Project: P2022-104  
 Application Numbers: R22-045, DP22-127

**Subject: Development Application (R22-104) at 9099, 9107 & 9111 Cedar Street – Rezoning Report**

**DATE:** March 17, 2025  
**BYLAW / PERMIT #:** 6332-2024-5949(178)  
 6333-2024 (Street naming)  
**PROPERTY ADDRESSES:** 9099, 9107, 9111 Cedar Street  
**LOCATION:** Cedar Valley  
**CURRENT ZONING:** Suburban 20 Zone (S20)  
**PROPOSED ZONING:** Multi-unit Townhouse One Zone (MT1)  
**CURRENT OCP:** Attached Multi-unit Residential  
**PROPOSED OCP:** No change  
**PROPOSAL:**  
 To allow for a 45-unit townhouse project.

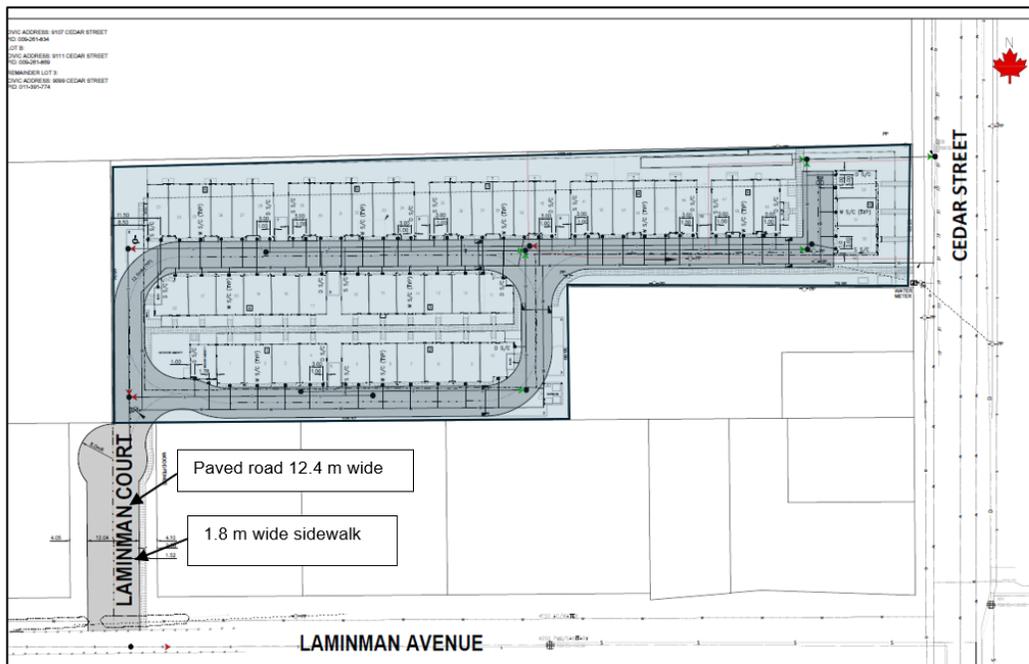
### 1. Rationale for tandem parking and other variance requests

A question was also raised regarding the variance to reduce the width of a parking stall, adjacent to a wall/building, from 3.0 m to 2.6 m. With the revised site plan the width of all of the parking stalls adjacent to buildings was increased to 3.0 m, and thus the width of all parking stalls is bylaw compliant.

The applicant has responded to Council's concerns regarding the requested variances to the tandem parking requirements with a revised site plan, which has eliminated the tandem parking variances. All tandem parking is now bylaw compliant. Table 4 - Parking – has been updated in this report to provide further information and clarification

## Development Permit DP22-059 – Multi Unit Residential

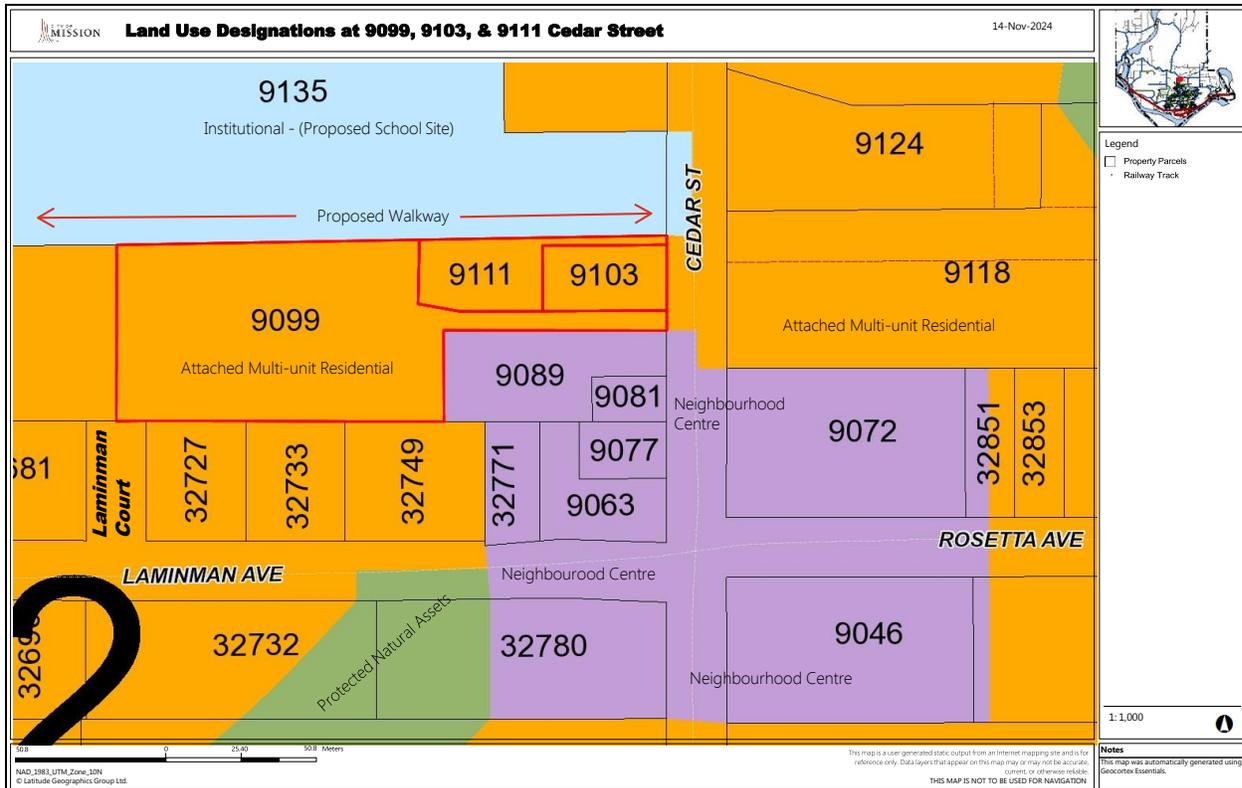
While the development of the site has been designed to meet the several aesthetic aspects of the form and character guidelines, the applicant seeks to alter the yard setbacks, maximum building height, and parking provisions of the Zoning Bylaw. The location of the variances is identified in **Attachment F**. The requested design variances that are incorporated into the Development Permit are identified on Tables 1, 2 and 3 below.

Staff support the north side yard relaxations that flank the proposed public walkway and school yard. The proximity buildings of the property line will not interface with other residential dwellings since a school will be built to the north. Therefore, the issue of privacy intrusion to other residential dwellings is muted. Given that there will be a public walkway flanking the northern lot line, it is beneficial to have dwelling units acting as the “eyes on the street” over the public walkway and future school yard. This is in keeping with CPTED (Crime Prevention through Environmental Design) principles. For this reason, the relaxations in the north side yard setback are supported.

Staff support the relaxations in building height. The building height variance of 0.2 m for buildings 8 and 9 is minor and reflects minor variations in the site’s grading. The increase in height will hardly be noticed given all buildings utilize roof decks as part of the private amenity area and only the relatively small roof top access portal projects above the allowable height.
